## HISTORIC PRESERVATION REVIEW BOARD STAFF REPORT AND RECOMMENDATION

Landmark/District:	<b>Anacostia Historic District</b>	(x) Agenda
Address:	<b>2001-2027 Martin Luther King Jr. Avenue SE</b>	
Meeting Date:	<b>September 24, 2015</b>	(x) New construction
Case Number:	<b>15-504</b>	(x) Subdivision
Staff Reviewer:	<b>Tim Dennée</b>	(x) Concept

*The historic buildings retain footprints similar to those depicted in this 1926 Sanborn map. The buildings at 2007 and 2021 Martin Luther King Jr. Avenue have substantial additions, and they were added early.*

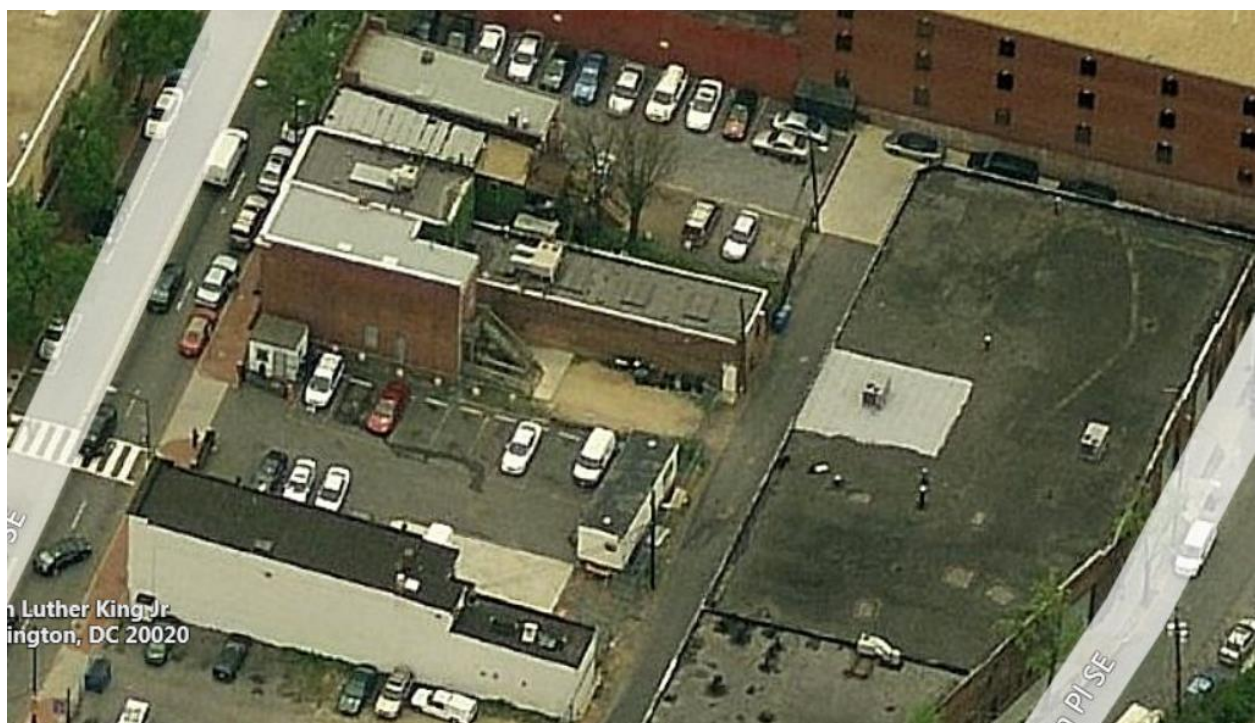
The plans do not depict well the proposed demolition, but as suggested by Sheet 13, most of the contributing buildings would be retained whole. A print shop addition to 2021 MLK—added to the first Union Savings Bank/Anacostia Bank building (1906)—would be demolished, as would a one-story accessory addition to 2007 MLK, which was originally a funeral parlor (1929). A little of the rear of the two-story section of 2007 MLK would go as well, part original block, part addition. The amount and nature of the demolition proposed do not suggest that it would constitute demolition “in significant part” of the character-defining portions of the contributing buildings. Still, there should be a preservation scope of work offered to compensate for the demolition and other effects. Both 2007 and 2019 Martin Luther King could use some façade restoration.
